## SERVICE BULLETIN SB99.11

**Machines/Models:** SB60 - Gas

**Serial Numbers:**  
1102-1258

**PURPOSE:** Improve Starting and Charging performance.

Figure 1

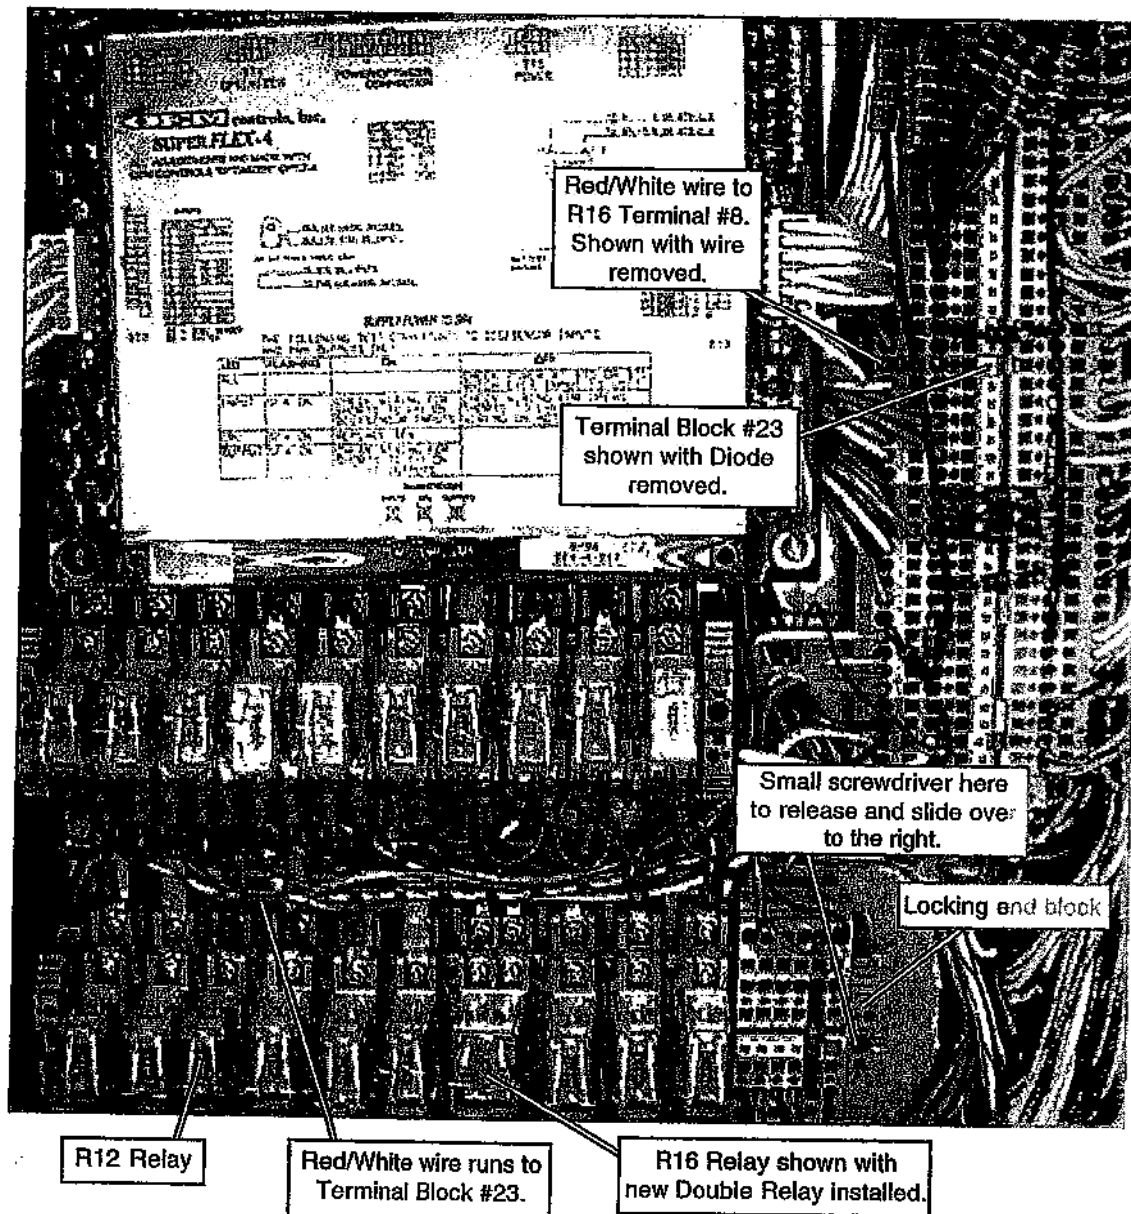
11. Locate R16 relay inside lower control box (bottom row 7th from left) and remove from socket. This will eliminate the need to re-identify the relay socket in the following steps. See Figure 1.

12. Loosen the din rail locking end block located on the right side of the relays and terminal blocks, using a small flathead screwdriver in the center hole, and slide the terminal blocks and relays (from the R16 relay) over to the right end of the din rail without sliding off. See Figure 1.

15. Locate terminal block #23 (See Figure 1). Remove and discard the diode by inserting a small seal pick into the square holes between the diode wires. Remove the Red/White wire on the *left* side of same terminal block #23 in the same manner. The Red/White wire on the *right* side of the same terminal block will remain.

Figure 2

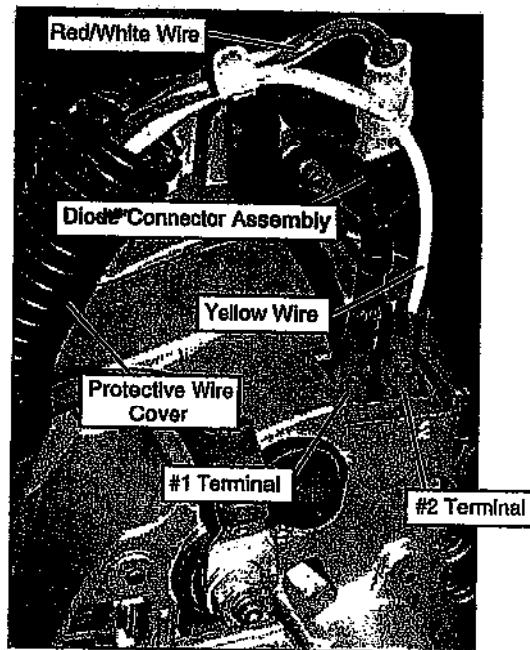
1. Remove the negative battery cable from battery (under radiator).
2. Swing engine tray out and install engine tray lock.
3. Cut and remove the plastic tie straps from protective wire cover starting at the alternator to the starter then to the Barber Coleman governor control. Note location of Tie Straps before removal as new Tie Straps will be installed later. See Figure 2.

4. Attach Diode Connector Assembly (#030948-003) to #1 terminal of alternator. See Figure 2.
5. Locate and remove the Red/White wire at #2 terminal on the alternator and attach it to the Diode Connector Assembly (#030948-003) installed in Step 4. See Figure 2.

6. Attach the push connector of the Yellow Wire Assembly (#030948-002), to terminal #2 of alternator. See Figure 2.
7. Route unattached end of newly installed Yellow Wire Assembly (#030948-002) through the protective plastic cover to the starter and attach to large terminal (bottom) of the solenoid (where battery cable is connected). See Figure 5.

Figure 3

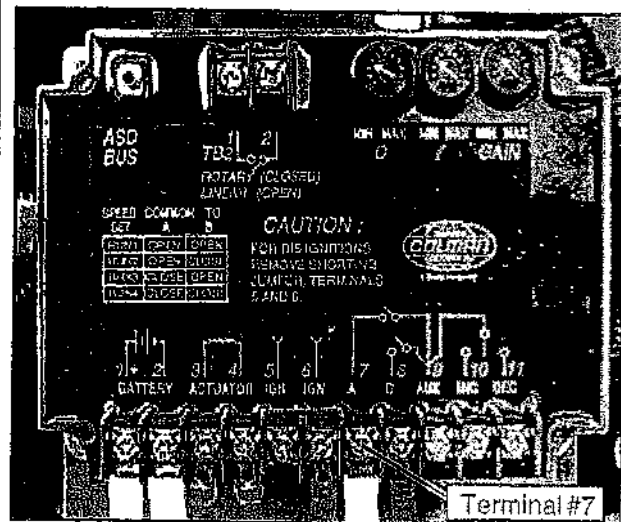
9. Route the unattached end (fork connector) of the newly installed Red/Black Wire Assembly with Diode (#030948-001) through the protective plastic cover to the Barber Coleman governor control and attach to #7 terminal. Do not remove the existing wire. See Figure 3 and 5.

Figure 4

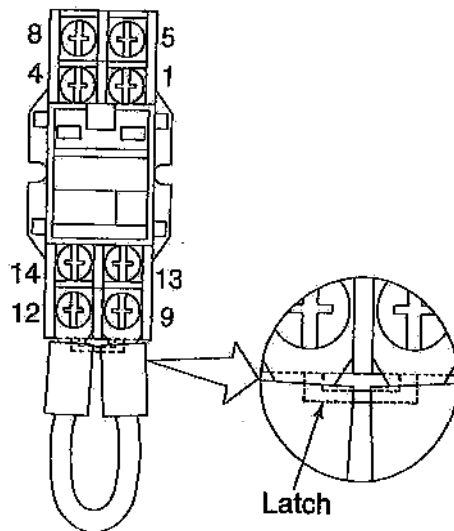
13. Remove wires from the R16 relay socket and remove socket from din rail by pulling down latch on bottom (use a small straight seal pick). See Figure 4.

14. Using Double Relay Socket (#067662-002) attach the two red wires (separated), one on terminal #9 and the other on terminal #12 (bottom) with the red jumper wire already there. Do not remove the red jumper wire. Attach Red/Black/White wire to terminal #14. Attach the two Black wires to terminal #13. Attach Red wire to terminal #8 (top). See Figure 4 for terminal locations.

Figure 5

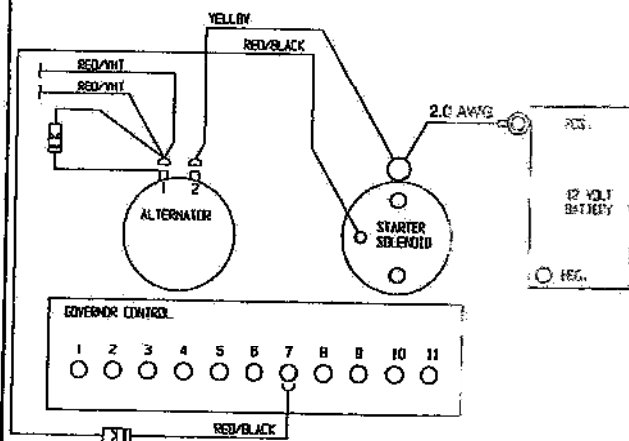
8. Attach #10 Ring Connector of the Red/Black Wire Assembly with Diode (#030948-001) to the start position (small post) of the starter solenoid. Do not remove existing wires. See Figure 5.
